8.0 REVISED SECTION 4.18 TO ANO-1 TECHNICAL SPECIFICATIONS

9.0 DETAILED DISCUSSION OF CHANGES TO SECTION 4.18:

This change request includes the following changes to the ANO-1 Technical Specifications 4.18 pertaining to Steam Generator Tubing Surveillance.

FIGURE 4.18.1

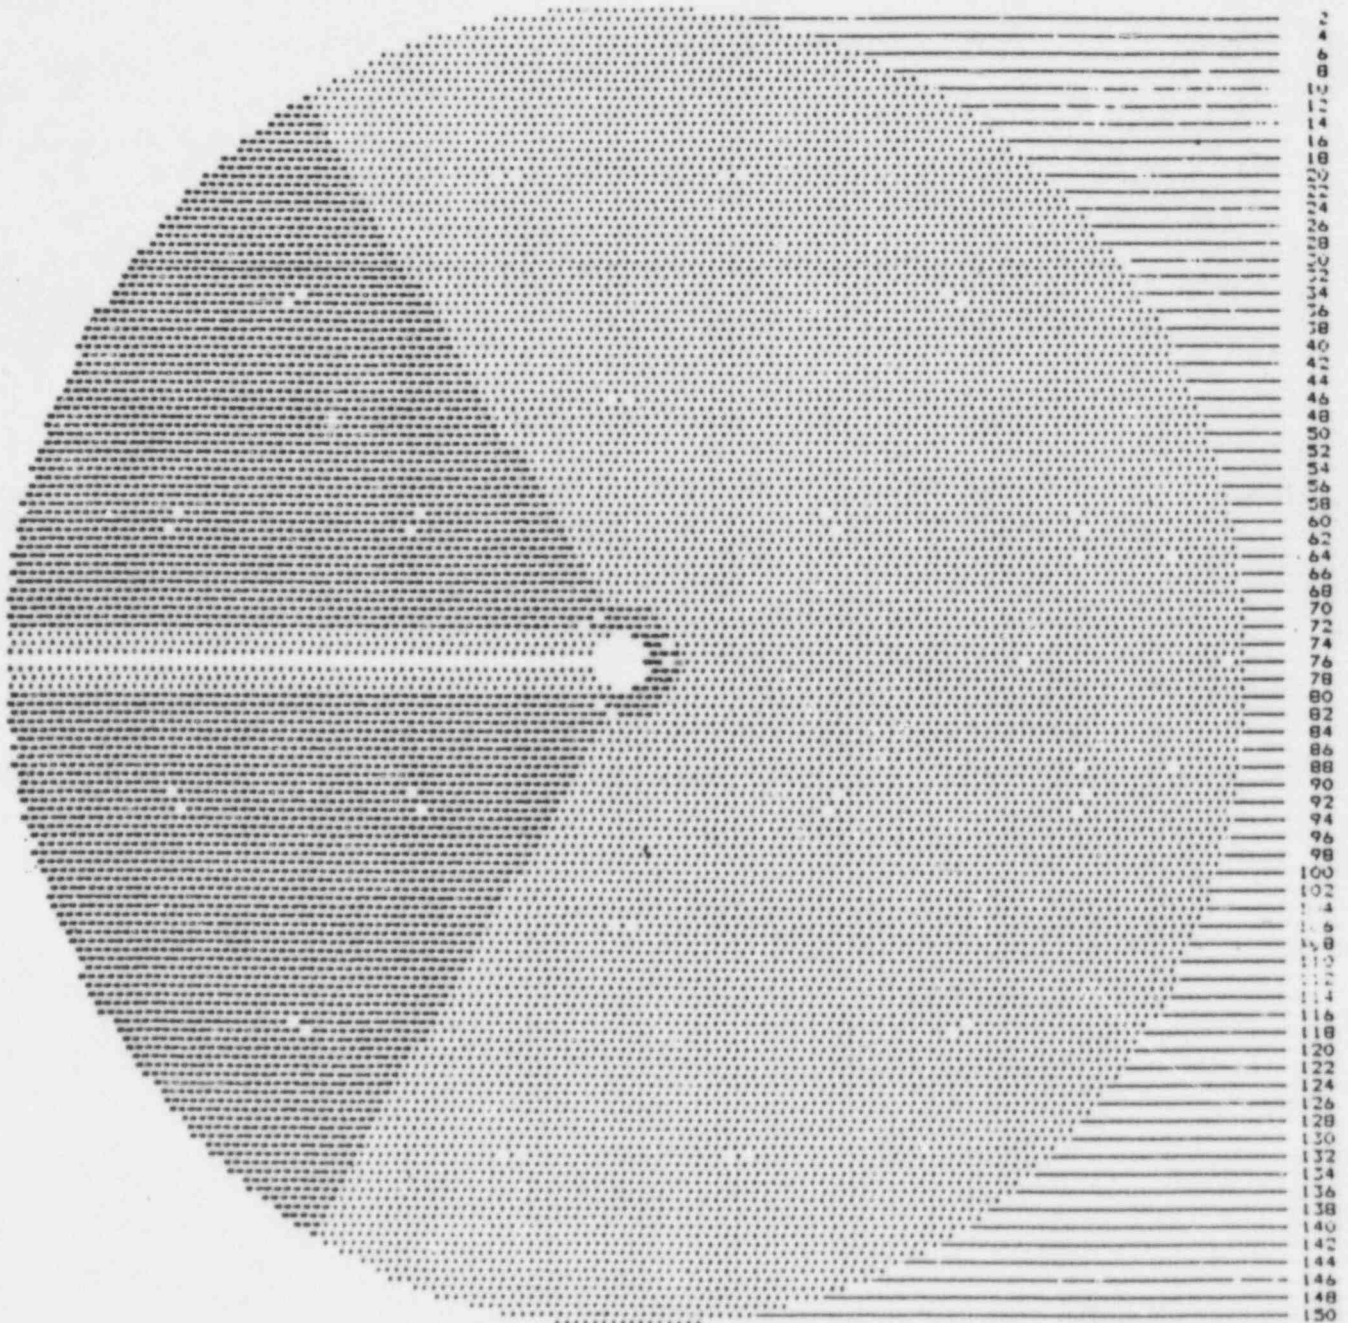
- n. Figure 4.18.1: The figure is revised to include an additional 51 tubes which surround the untubed center portion of the steam generator and which are expected to be susceptible to the same form of degradation as the wedge-shaped group which surrounds the untubed lane region.

The intent of this change is to include these additional tubes as a part of group A-3. As a part of this special group, these tubes will receive increased scrutiny.
